# Determination 2023/015

**Regarding the decision to issue a code compliance certificate for the construction of the foundation and floor slab of a vehicle storage and maintenance shed**

**2 to 6 Bidois Road, Fairy Springs, Rotorua**

**Figure 3: Foundation system and floor slab (not to scale)**

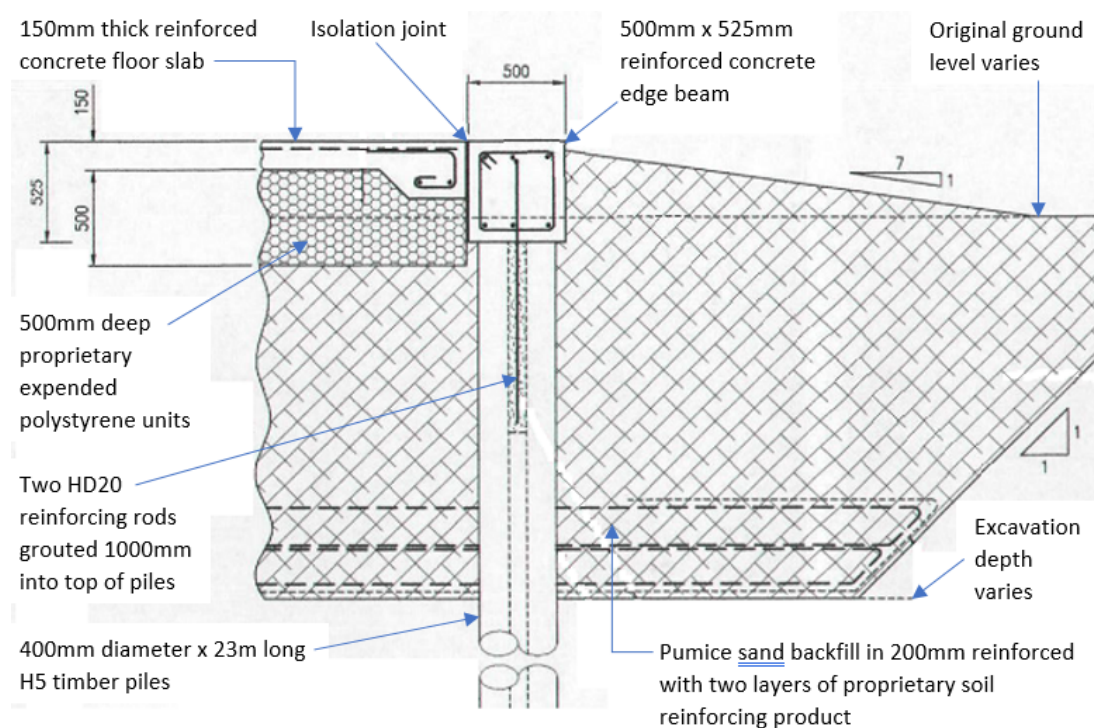
- 2.7. In the consented design, the piles support a 500mm wide by 525mm deep reinforced concrete edge beam which extends around the perimeter of the truck shed. Refer to figure 3.

- 2.8. There is a 150mm thick reinforced concrete floor slab. This incorporates a 300mm deep thickening around the four edges of the slab. The floor slab is separated from the perimeter edge beam by an isolation joint (refer to figure 3).

- 2.9. The finished height of the floor slab is designed to be level with the top surface of the perimeter edge beam. Refer to figure 3.
- 2.10. The specification on plan sheet 1 of 3 stated all reinforced concrete material and construction shall comply with New Zealand Standards *NZS 3101:2006 Concrete structures standard* and *NZS 3109:2006 Concrete construction*.<sup>19</sup>

truck shed, with the top surface sloped downwards and away from the “edge beam”.<sup>22</sup> Refer to figure 3.

**Figure 4: Location of survey points (not to scale).**

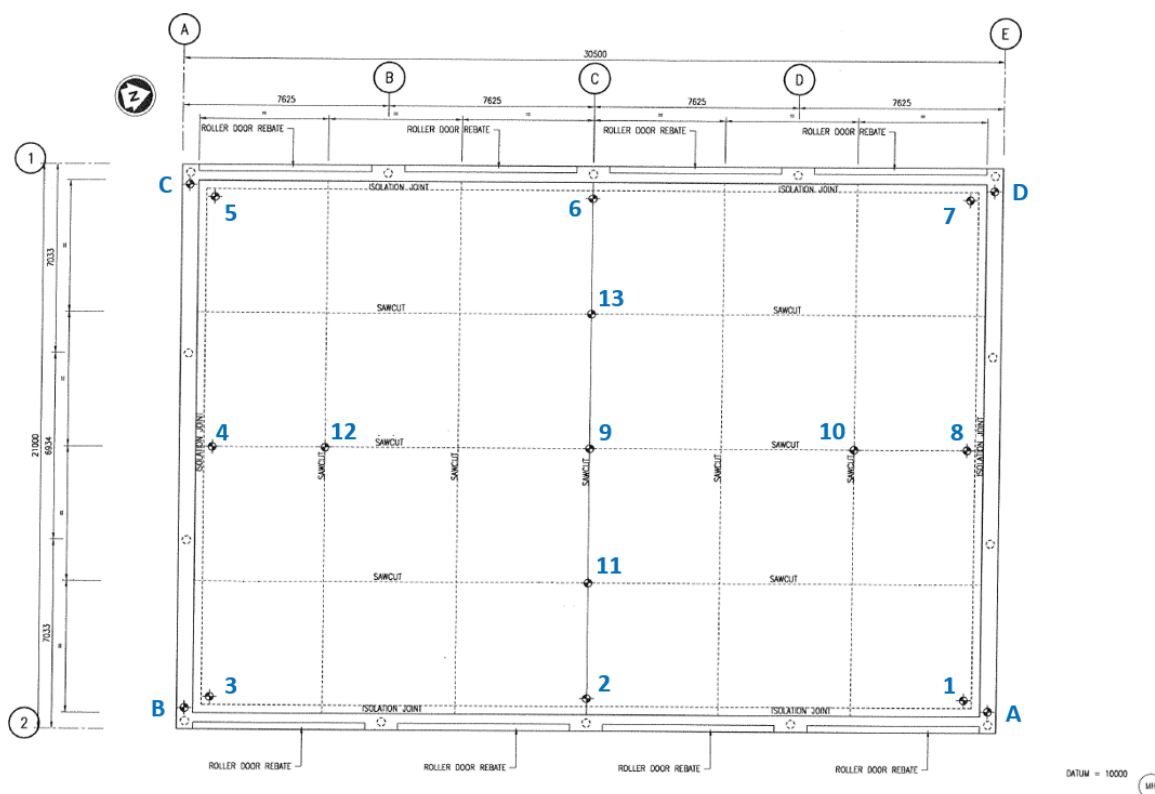
3.19. Several settlement monitoring surveys were carried out by engineer 2 between 3 July 2015 (the initial survey) and 17 November 2015.<sup>42</sup> The survey measured four points on the top of the perimeter edge beam at the corners of the truck shed, and 13 reference points spaced at different locations across the floor slab. Refer to figure 4.

adjacent to them. The survey datum point is the manhole shown outside the northeast corner of the truck shed to the bottom right of figure 4).
